Submission on the Stage 2 EIS for the Northern Beaches Hospital (SSI 6792)

Warringah Council Submission

Stage 2 Environmental Impact Statement State Significant Infrastructure (SSI 6792) Northern Beaches Hospital

Appendix A – Location of Coastal Upland Swamp EC in relation to F2

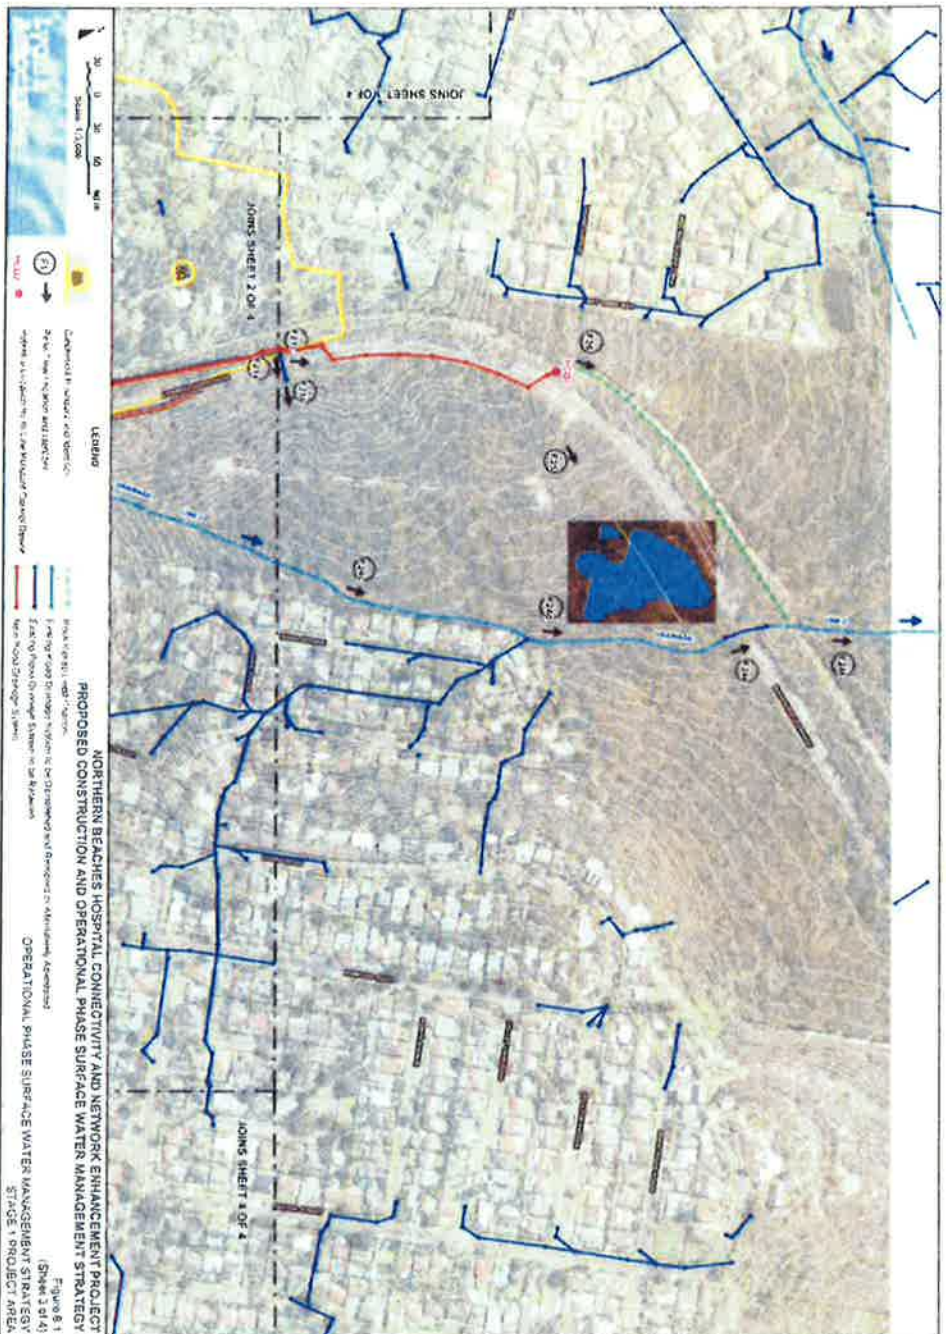
The Biodiversity Assessment Report (Vol. 2, Table 13, pg.118) indicates that this EEC does not occur within a 10km radius of the site, however Figure 4 (pg. 23) and Figure 6 (pg.48) within the same report and Figures 9-3 of Environment Impact Statement (Vol. 1, pg. 204) contradicts this which shows the occurrence of vegetation attributed to the Coastal Upland Swamp EEC outside of the study area adjacent to the Wakehurst Parkway in the north.

That the potential occurrence of the Coastal Upland Swamp EEC be verified on the ground where any changes in hydrology are proposed. The study area should be extended to include areas that are potentially indirectly impacted by hydrological changes.
